Re: Administrative Order 2RF-127
Muy Wayno Recycling Facility Containment Upgrade
Facility ID (fab1807557108)

XTO Permian Operating, LLC. respectfully requests permission to perform upgrades to the Muy Wayno Recycling Facility Containment Permit 2RF-127 Recycling Facility ID (fab1807557108).

OVERALL SITE LAYOUT
MUY WAYNO FRAC POND
SC: 1/32" = 1'-0"

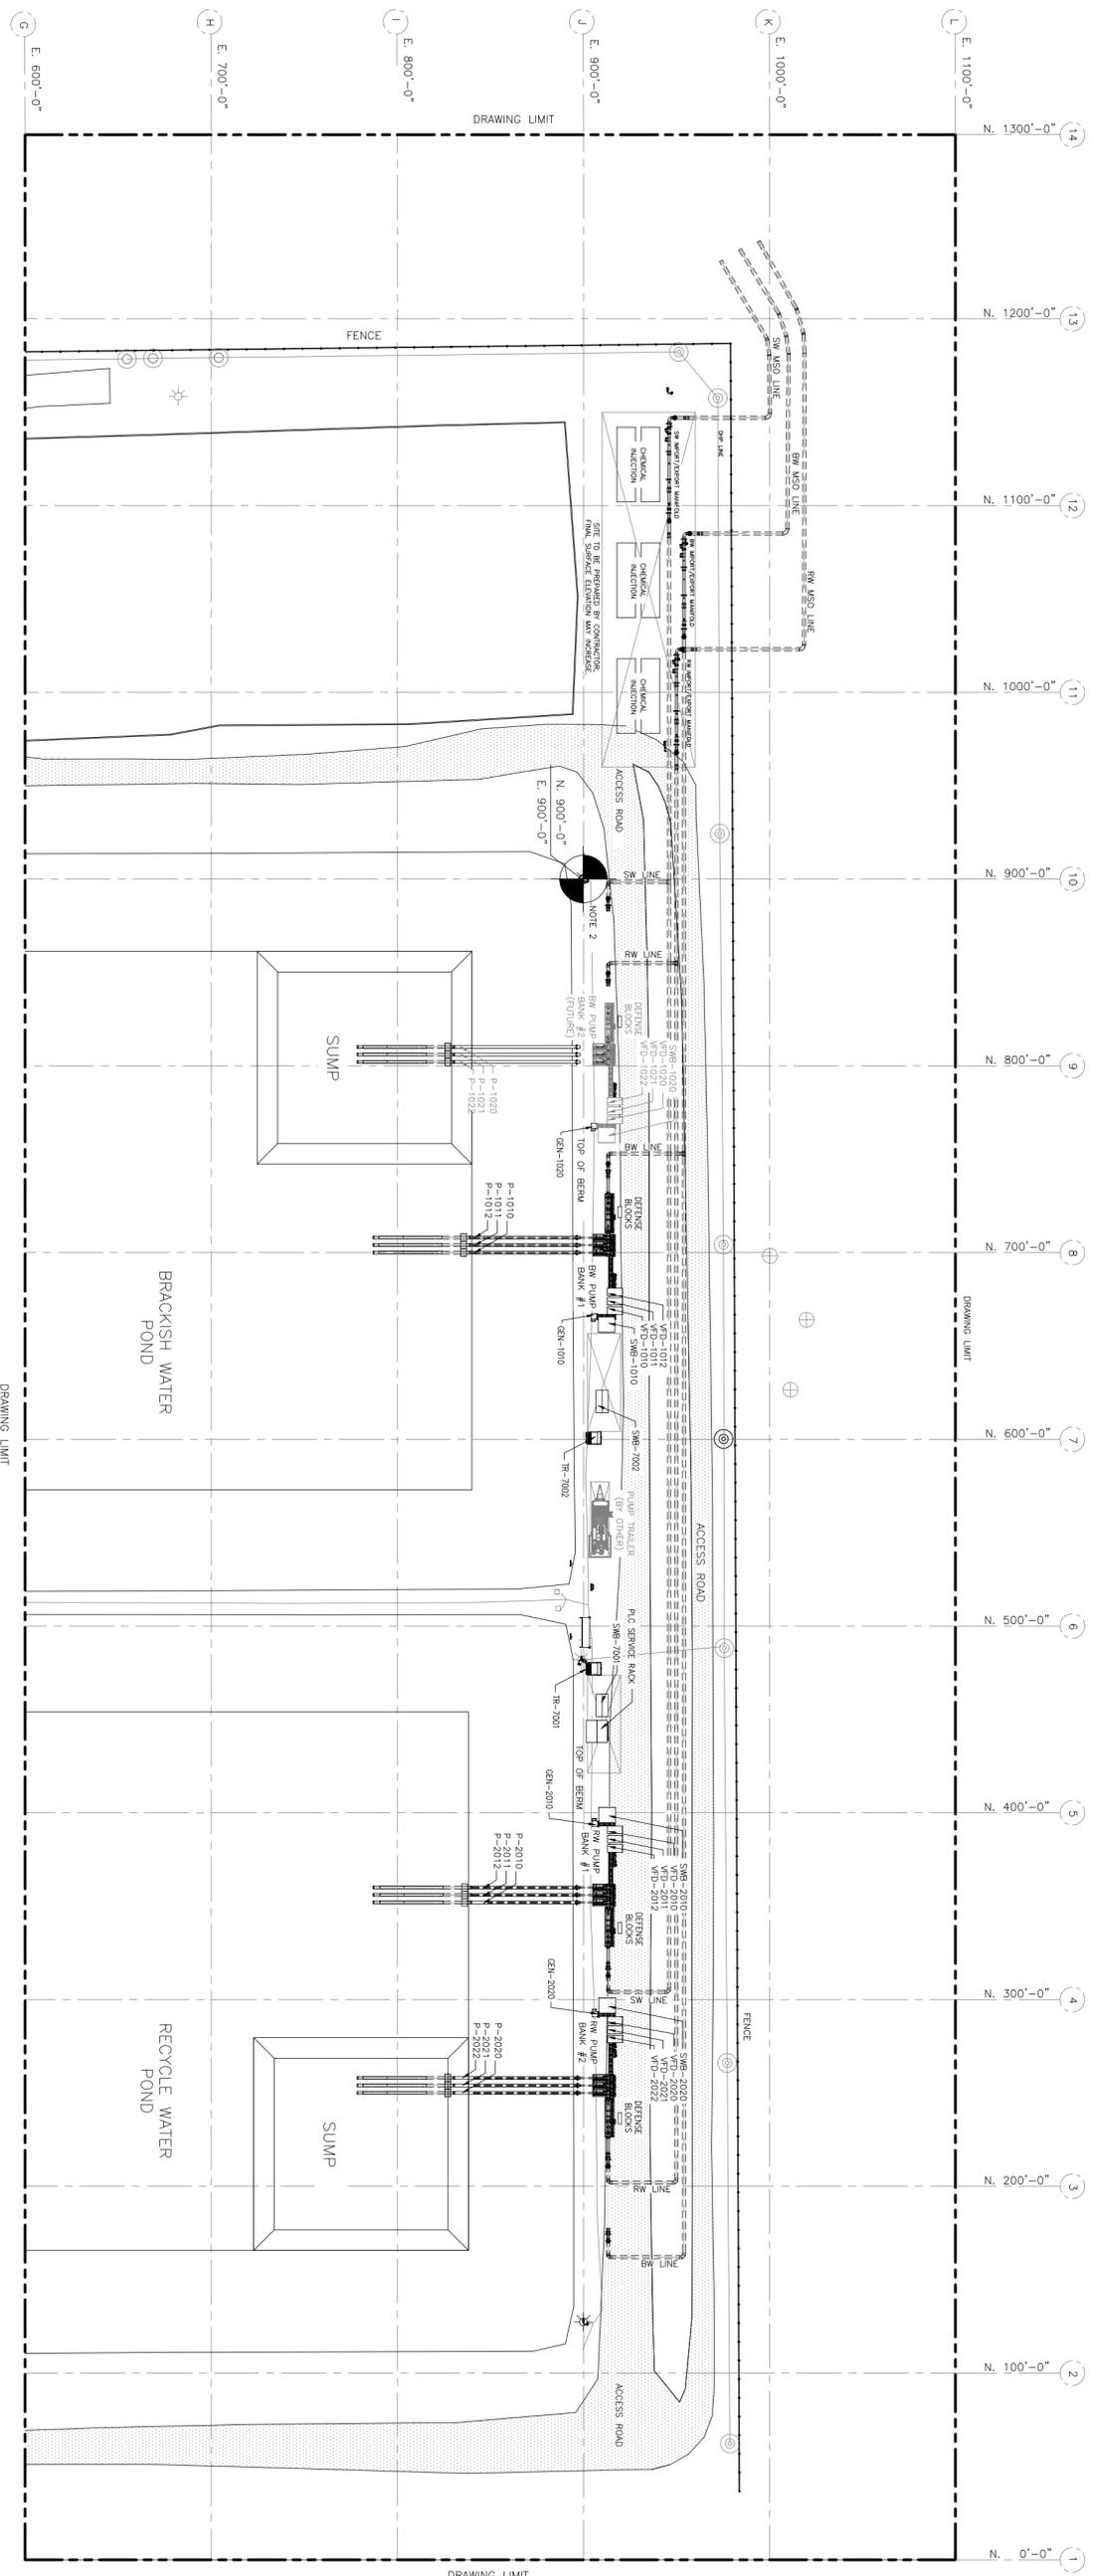
The scope of the work to be done on the Muy Wayno frac pond is as follows: installation of mechanical and electrical infrastructure (i.e., electric submersible pumps, transformers, switchboards, etc.) to support upcoming developments and eliminate the use of temporary pumps. The following equipment will be added as part of the upgrade:

Quantity	Description	Temporary	Permanent
9	250HP Electric Submersible Pump	X	
2	2.6MVA Transformer		X
2	3000A Switchboard		X
1	Programmable Logic Controller (PLC)		X
4	1200A Generator Tap Boxes		X
9	300HP Variable Frequency Drive (VFD)	X	
1	2000A Switchboard	X	
2	1200A Switchboard	X

An updated engineered drawing of the frac pond layout can be viewed in drawing DN-PLMYW-FP-PF-MP-LAY-0001 (attached).

NMOCD has reviewed the proposed recycling facility updates submitted by [373075] XTO PERMIAN OPERATING LLC on 07/26/2024, for 2RF-127 - MUY WAYNO RECYCLING FACILITY ID [fAB1807557108], Action ID 367526. The proposed update to be done on the 2RF-127 - MUY WAYNO RECYCLING FACILITY ID [fAB1807557108] is as follows: installation of mechanical and electrical infrastructure (i.e., electric submersible pumps, transformers, switchboards, etc.) to support upcoming developments and eliminate the use of temporary diesel pumps. The proposed recycling facility updates have been approved with the following conditions of approval:

Delaware Frac Pond Process Flow (1 of 2)

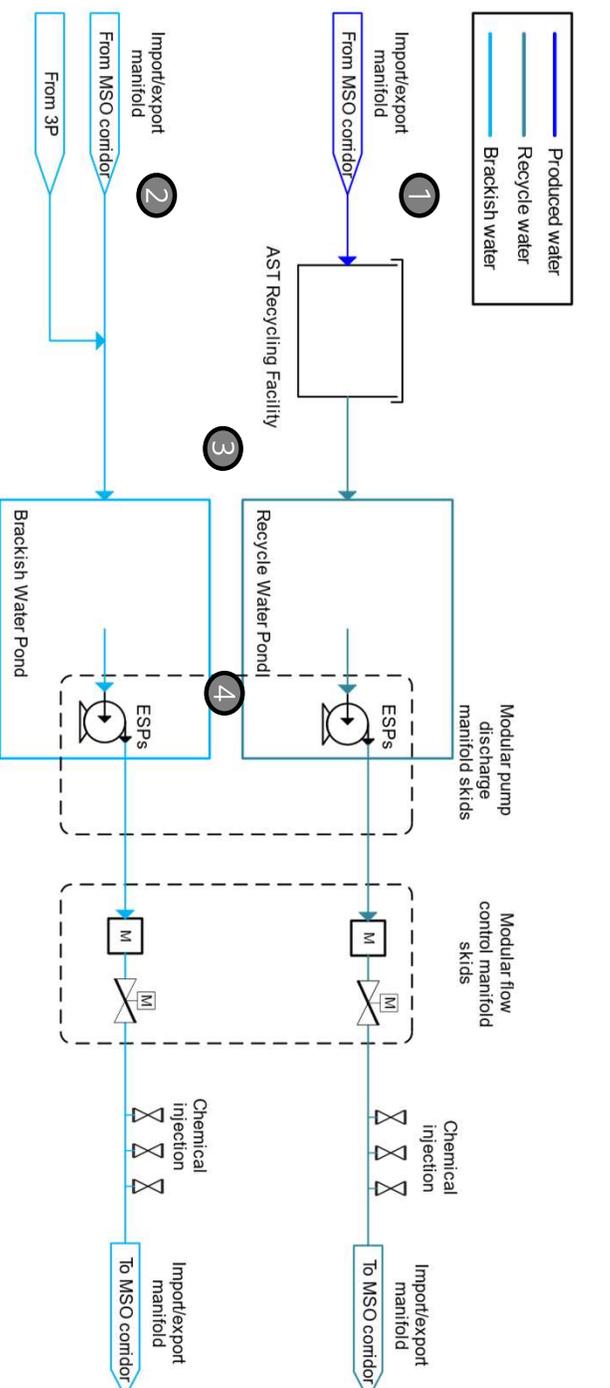
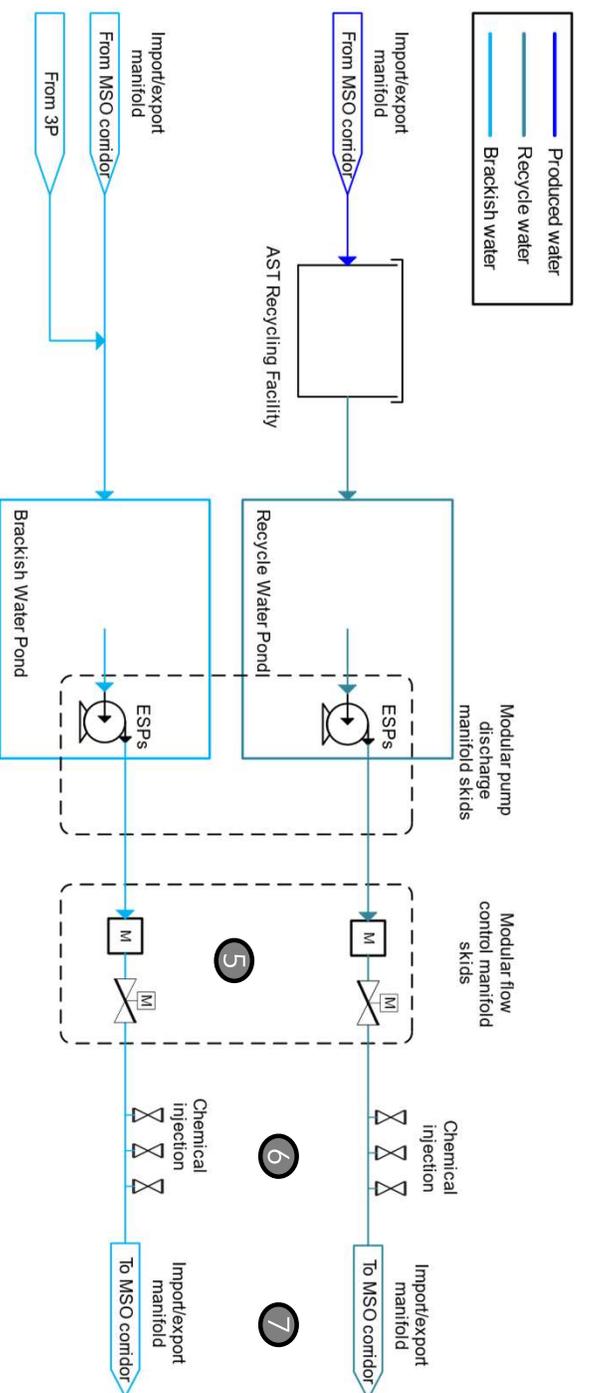
A process flow diagram can be viewed in "Delaware Frac Pond Process Flow" (attached).
